Date: August 17, 2007
To: T10 Technical Committee
From: Alvin Cox (alvin.cox@seagate.com)
Subject: SAS-2 6Gbps PHY Electrical Specification

Abstract: The attached information defines the electrical requirements for 6 Gbps transmitter devices and receiver device. In addition, updates include reference transmitter and receiver device definitions to provide a means of determining if a channel is compliant and a cable specification section with requirements for 6Gbps usage. This proposal is a continuation of 07-063, at it ran out of revisions available.

Figure 105 — Example 6Gbps TxRx connection compliance testing

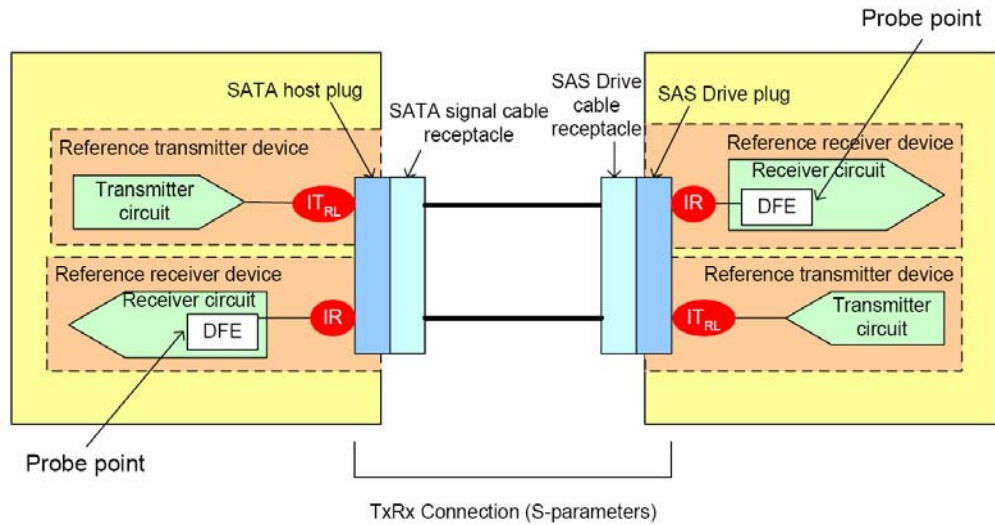
For 6 Gbps applications, the TxRx connection shall support a bit error ratio (BER) that is less than 10^{-15} (i.e., fewer than one bit error per 10^{15} bits) based on digital communication link simulation results, with data input from S-parameter measurements of the TxRx connection, the specified reference transmitter device, and the specified reference receiver device. Figure 105 illustrates an example circuit for simulation. The specific simulation program used is beyond the scope of this specification. Simulations typically do not include all aspects of noise that may degrade the received signal quality. The support of a BER that is less than 10^{-15} by simulation should yield an actual BER that is less than 10^{-12} . For external Mini SAS 4x cable assemblies, these electrical requirements are consistent with using good quality passive cable assemblies constructed with shielded twinaxial cable with 24 gauge solid wire up to 10 meters in length.

Figure 118 — Transmitter device common mode voltage limit

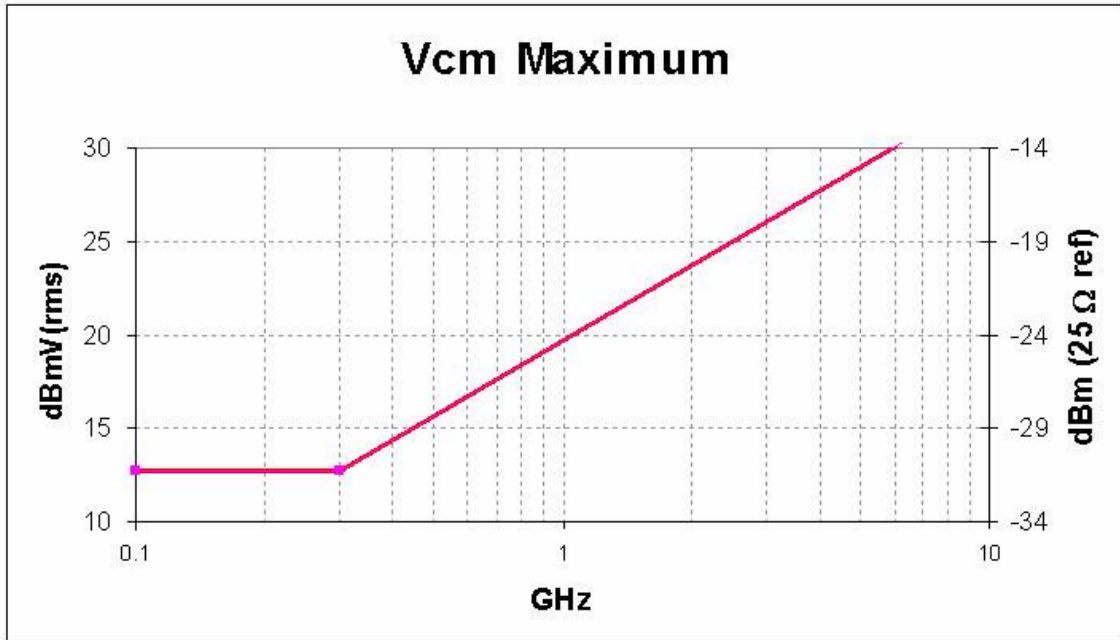
Flat line at 26 dBmV. No. Need more data.
 Range of 100 MHz to 6 GHz?
 What data pattern?
 Measured with 1 MHz bandwidth.

Figure 125 — Reference receiver device

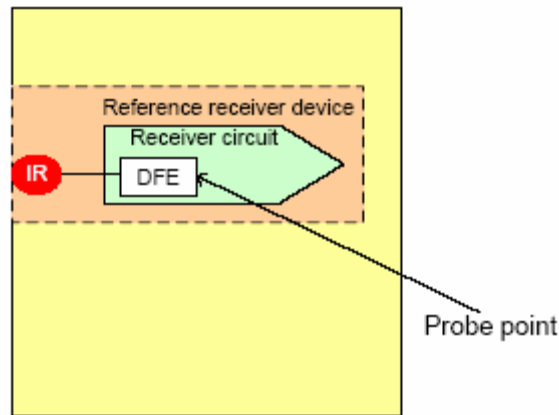
Need vertical and horizontal opening requirements to meet BER. Tbd and .4UI?
